**JOINT REGIONAL PLANNING PANEL  
(Sydney East Region)**

<b>JRPP No</b>	<b>2013SYE061</b>
<b>DA Number</b>	<b>DA.239/13</b>
<b>Local Government Area</b>	<b>North Sydney</b>
<b>Proposed Development</b>	<b>Demolition of existing structures and the construction of a mixed use development comprising basement levels, commercial floor space, and 197 residential apartments. A total of 146 car parking spaces are proposed</b>
<b>Street Address</b>	<b>144-154 Pacific Highway and 18 Berry Street North Sydney</b>
<b>Applicant/Owner</b>	<b>Strand Estates Pty Ltd</b>
<b>Number of Submissions</b>	<b>Nine (9)</b>
<b>Report by</b>	<b>Geoff Mossemenear, Executive Planner, North Sydney Council</b>

**Assessment Report and Recommendation**

EAST ELEVATION - FACING PACIFIC HWY

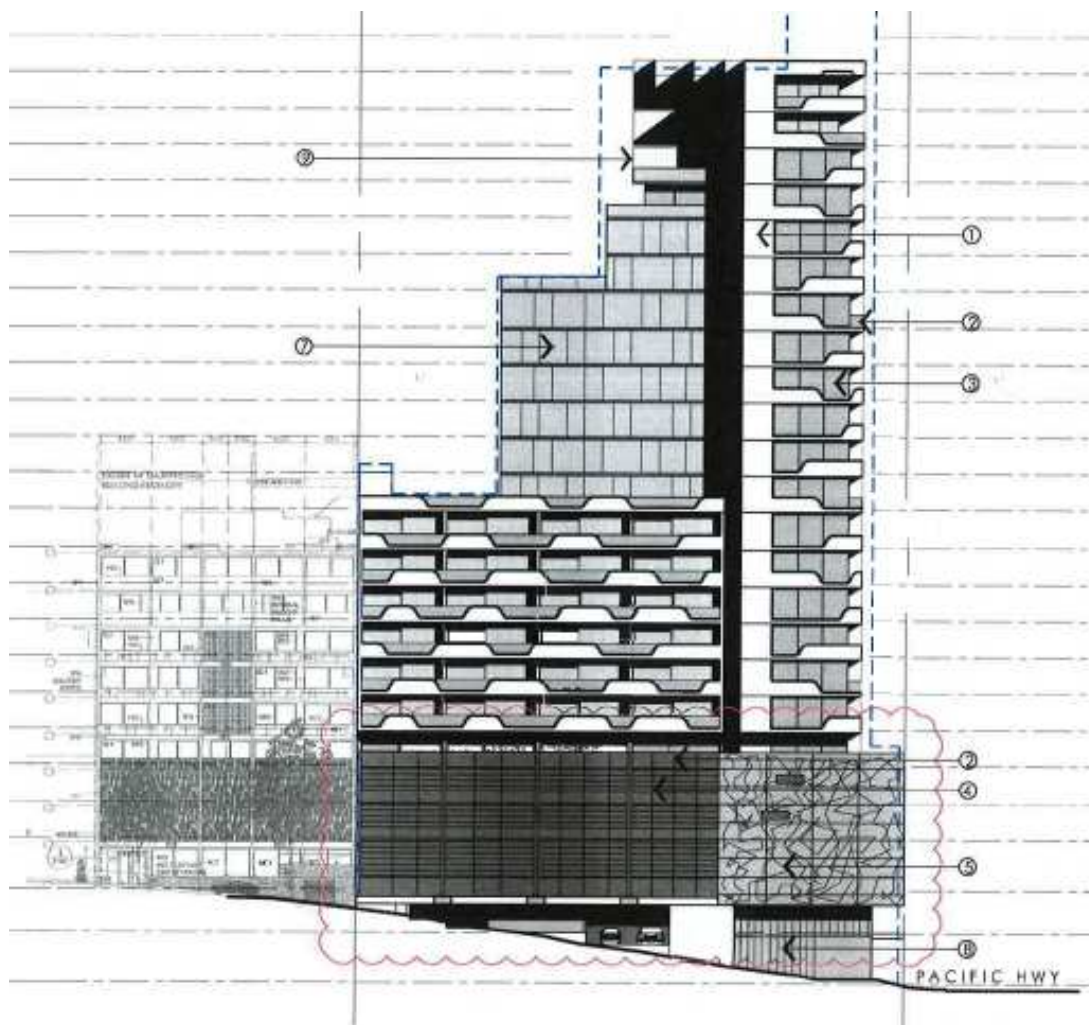
The height is excessive when assessed under the current and new LEP controls. The bulk and scale is not compatible to the nearby low scale residential area. The proposal does not satisfy the floor space ratio requirements for non residential floor area.

The height of the building is substantially over the height control under NSLEP 2013.
